**MOUNTAIN REGIONAL WATER SPECIAL SERVICE DISTRICT  
PARK CITY, UTAH**

**SIGNAL HILL WATER TREATMENT PLANT OPTIMIZATION**

**ENGINEER PROJECT NO. 203230**

**ADDENDUM NO. 2  
TO THE  
CONTRACT DOCUMENTS**

|                                                                                                                                                                                                                                       | <b>DRAWING NO.</b><br>30M01    |

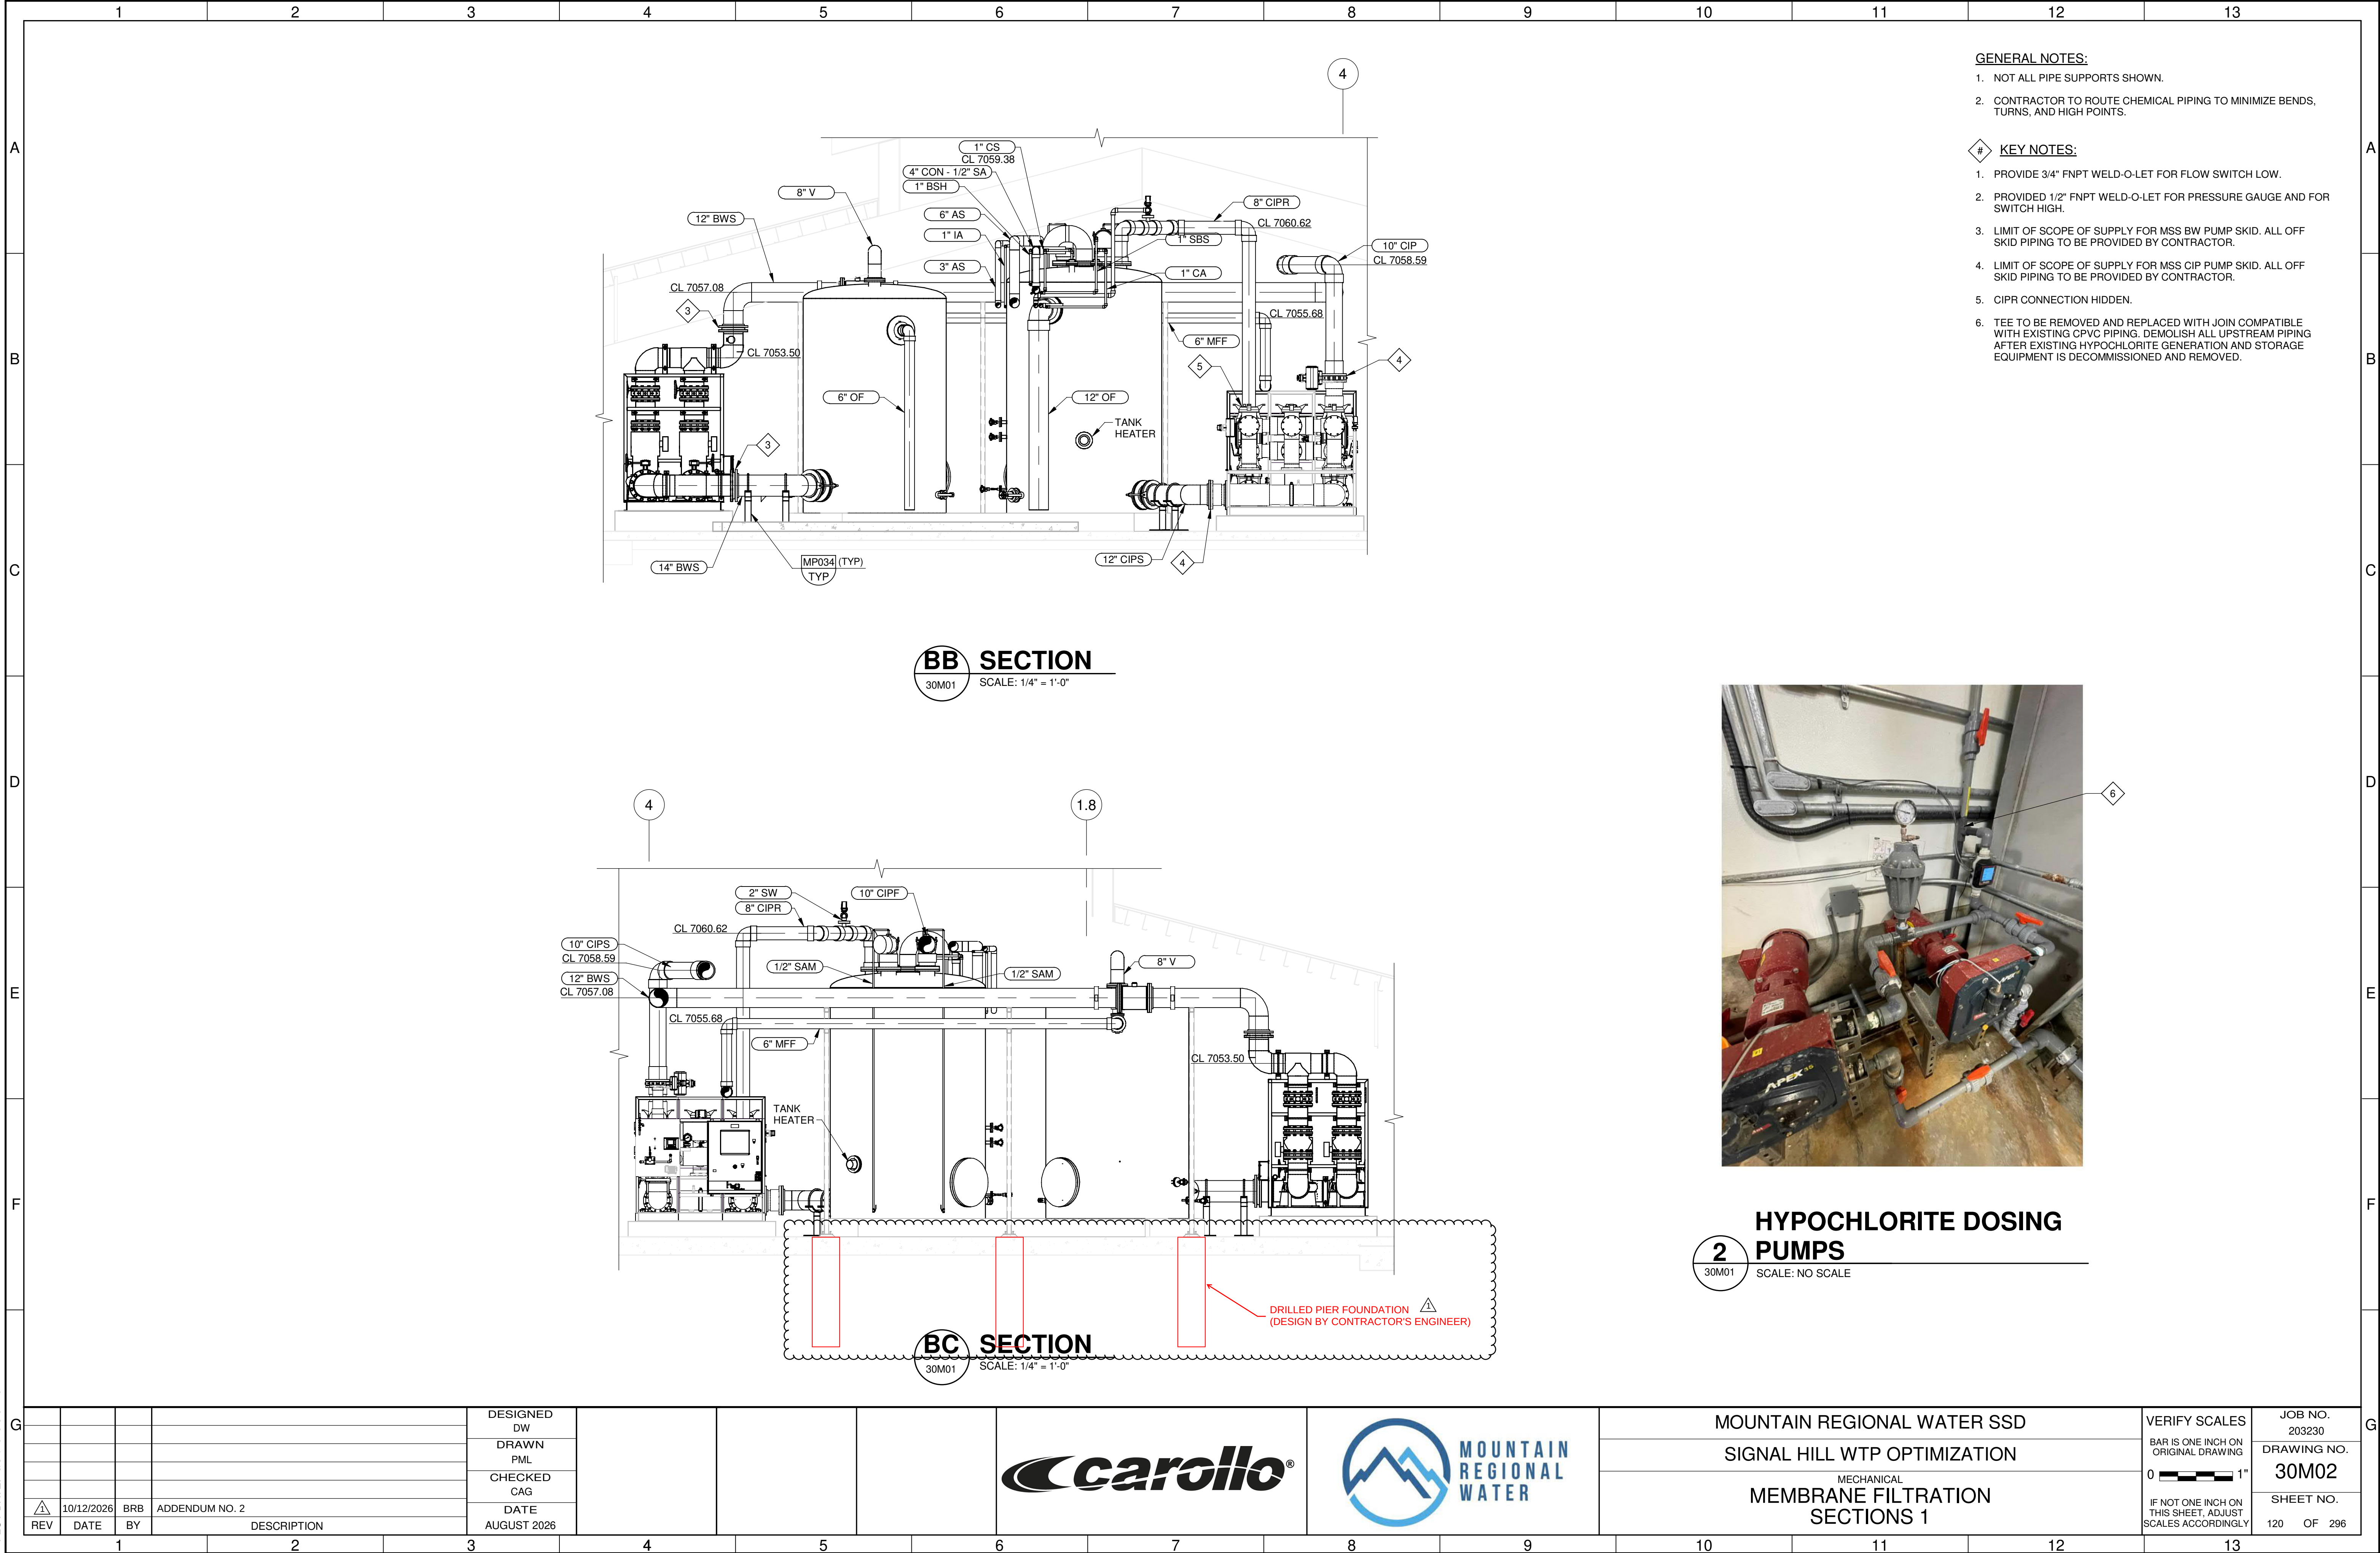
30. DRAWING 20M04:
  - a. REPLACE drawing in its entirety with the attached drawing.
31. DRAWING 30M01:
  - a. REPLACE drawing in its entirety with the attached drawing.

| <div><div></div><div>BIDDER QUESTION LOG</div></div>                                                                                                                                                                                                                                                                                                                                                                                                                                                                                                                                                                                                                                                                                                                                                                                                                                                                                                                                                                                                                                                                                         |                                                                                                                                                                                                                                                                                                                                                                                                         |
|--------------------------------------------------------------------------------------------------------------------------------------------------------------------------------------------------------------------------------------------------------------------------------------------------------------------------------------------------------------------------------------------------------------------------------------------------------------------------------------------------------------------------------------------------------------------------------------------------------------------------------------------------------------------------------------------------------------------------------------------------------------------------------------------------------------------------------------------------------------------------------------------------------------------------------------------------------------------------------------------------------------------------------------------------------------------------------------------------------------------------------------------------------------------------------------------------------------------------------------------------------------------------------------------------------------|---------------------------------------------------------------------------------------------------------------------------------------------------------------------------------------------------------------------------------------------------------------------------------------------------------------------------------------------------------------------------------------------------------|
| <p>Sheet 30M01 Membrane Filtration Plans call out for a 2" (DR) drain at the Backwash Tank and a 4" (DR) drain at the CIP tank. Per Key tag 14, the 4" UF CIP Drain Valve is provided by H2O Innovation. There is no call out for the 2" Backwash Tank Drain Valve. Will that valve also be supplied by H2O Innovation? If not, what is the type of valve and what is Specification ID number for the valve.</p>                                                                                                                                                                                                                                                                                                                                                                                                                                                                                                                                                                                                                                                                                                                                                                                                                                                                                             | <p>The 2" (DR) drain valve for the MF Backwash Tank will be provided by H2O Innovation. It is part of their submittal package in Appendix B of the specifications.</p>                                                                                                                                                                                                                                  |

MP510

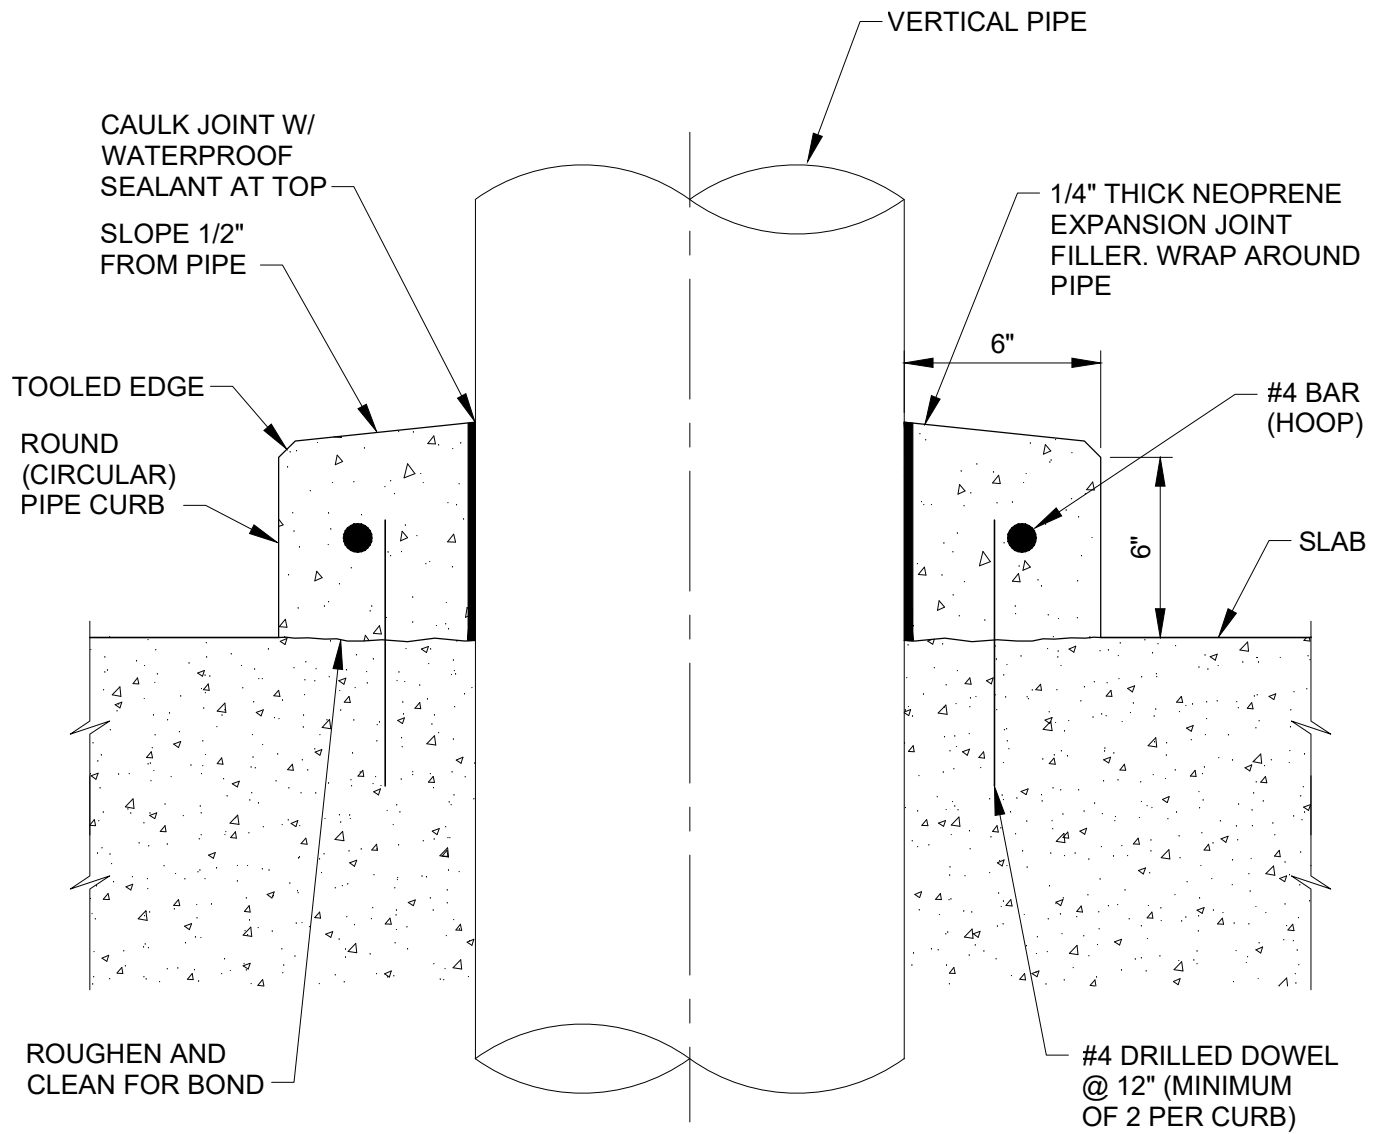
- a. ADD the attached Typical Detail MP510 to this drawing.

**SU605 GRATING - FRP - REBATE**

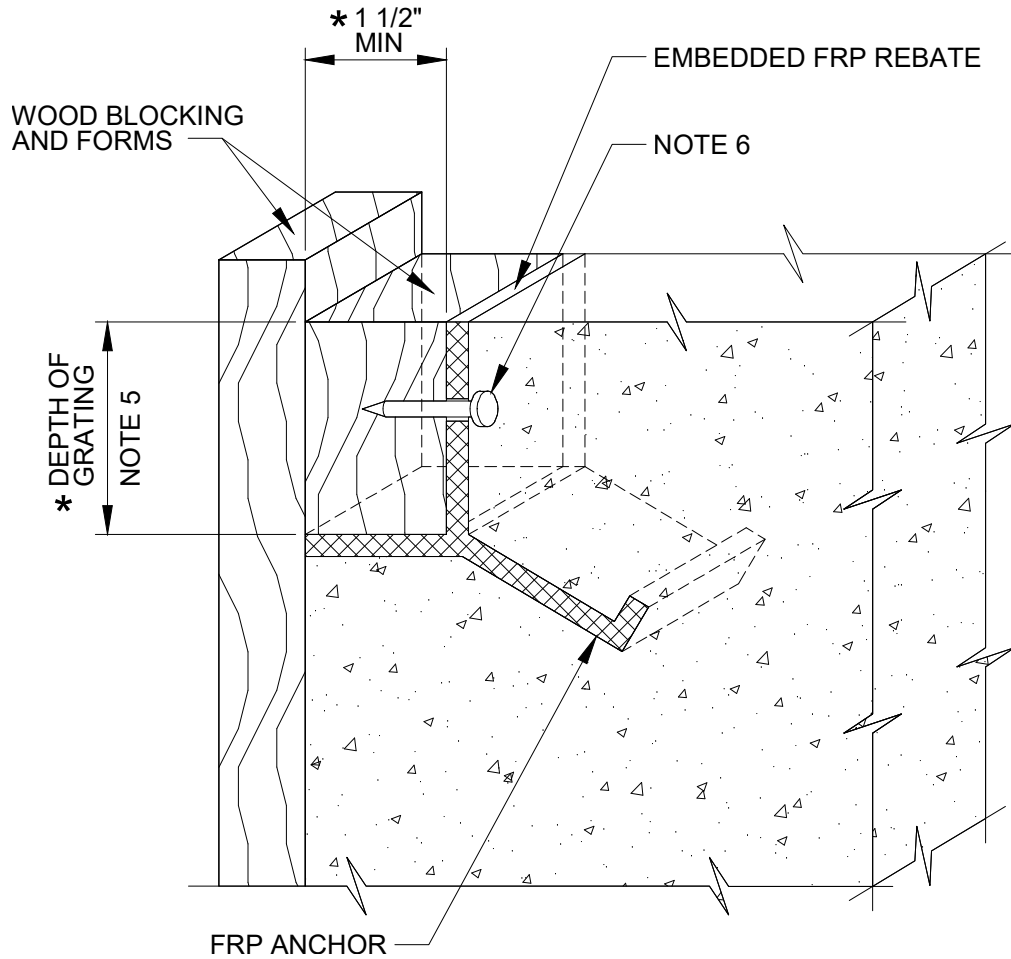
- a. ADD the attached Typical Detail SU605 to this drawing.
